Integration of Photometer PFM BDAs:
Alignment issues

Ref: SPIRE-RAL-NOT-
002662

TITLE: Integration of Photometer FS BDAs: alignment issues

Figure 2: Distribution of the measured FS BDAs centre positions in the focal plane wrt nominal

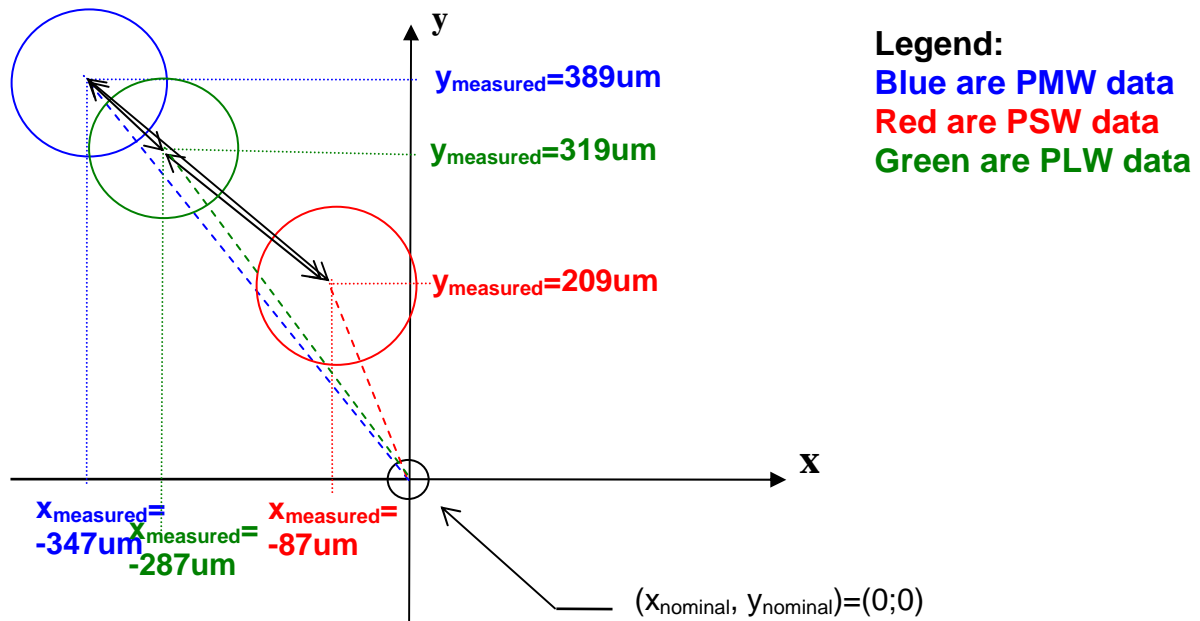
arrows) between PSW and PMW centres and PSW and PLW centres is $228 \pm 50 \mu\text{m}$ and $316 \pm 50 \mu\text{m}$ respectively .

It is therefore suggested to compensate at respective interface plate level:

- the PMW centre by $200 \mu\text{m}$ along $-y$ and $250 \mu\text{m}$ along $+x$,
- the PLW centre by $100 \mu\text{m}$ along $-y$ and $200 \mu\text{m}$ along $+x$.

Figure 1 (excerpt from ICD dwg 10209721, with coordinate axes shown)

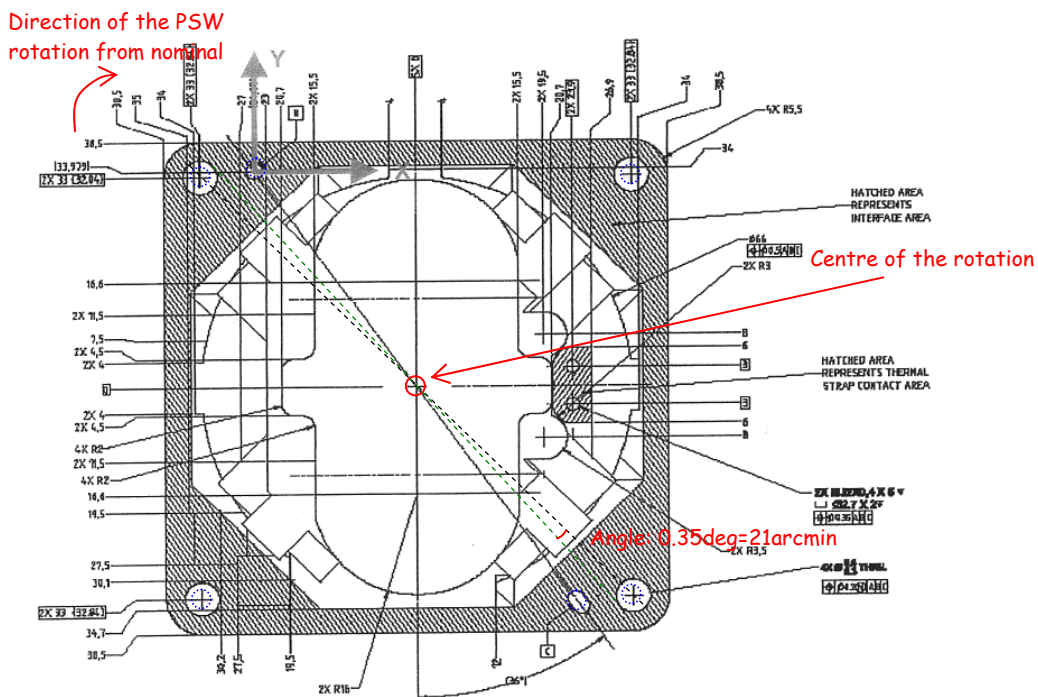
- **PSW interface:** only the in-plane (x-y) rotation needs a correction by a rotation of the centres of mounting and reference points (dashed blue in sketch below) wrt overall plate about the nominal plate centre. Rotation angle is 0.35 deg (negative i.e. clockwise or from y to x) which at mounting point approximately located radially $33 \times 1.414 = 46.67 \text{ mm}$ away from centre the local tangential displacement needed is $46.67 \times \tan(0.35) \sim 285 \mu\text{m}$.

Figure 1 (excerpt from ICD dwg 10209721, with coordinate axes shown)

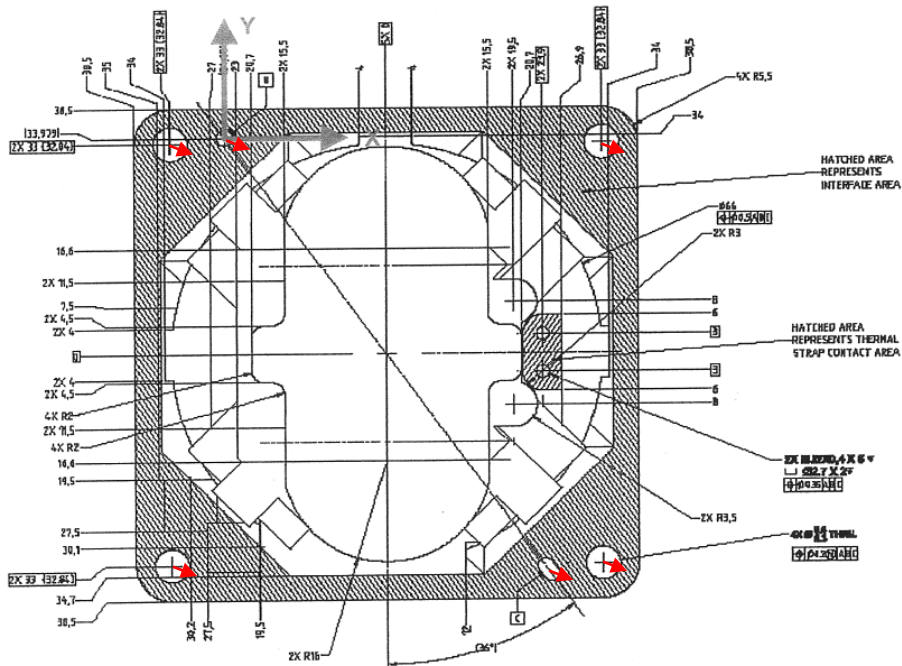
- **PMW interface:** the in-plane (x-y) rotation needs a correction by a rotation of the centres of mounting and reference points (dashed blue in sketch below) wrt overall plate about the nominal plate centre. Rotation angle is 0.35deg (positive i.e. counterclockwise or from x to y) which at a typical corner mounting point approximately located radially $33 \times 1.414 = 46.67\text{mm}$ away from centre the local tangential displacement (of its centre wrt nominal) needed is $46.67 \times \tan(0.35) \sim 285\mu\text{m}$.

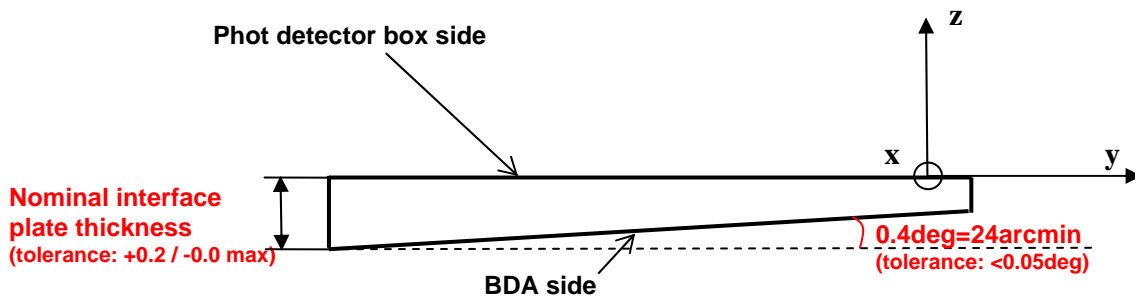
For the tilt of the feedhorn array plane wrt local z axis, all BDAs except PLW indicate a value (dominated by a rotation about the local x axis) which is at the edge of beyond the allowed requirement and therefore a correction for this measured tilt on the BDAs is strongly suggested.

⇒ **Consequences for interface plates on the case of PSW, PMW:** from the above considerations, it is suggested to machine the interface plates (for PMW and PSW) in a wedge shape for the schematic below.

NB: the removal of material from the nominal constant thickness interface plate will produce an axial shift along +z which is estimated to be of the order of +200-250µm max (suggested tolerance above tuned to minimise this). Added to the above nominal expected BDA internal defocus along z, the net result will still be well within the allocated +/-0.5mm.
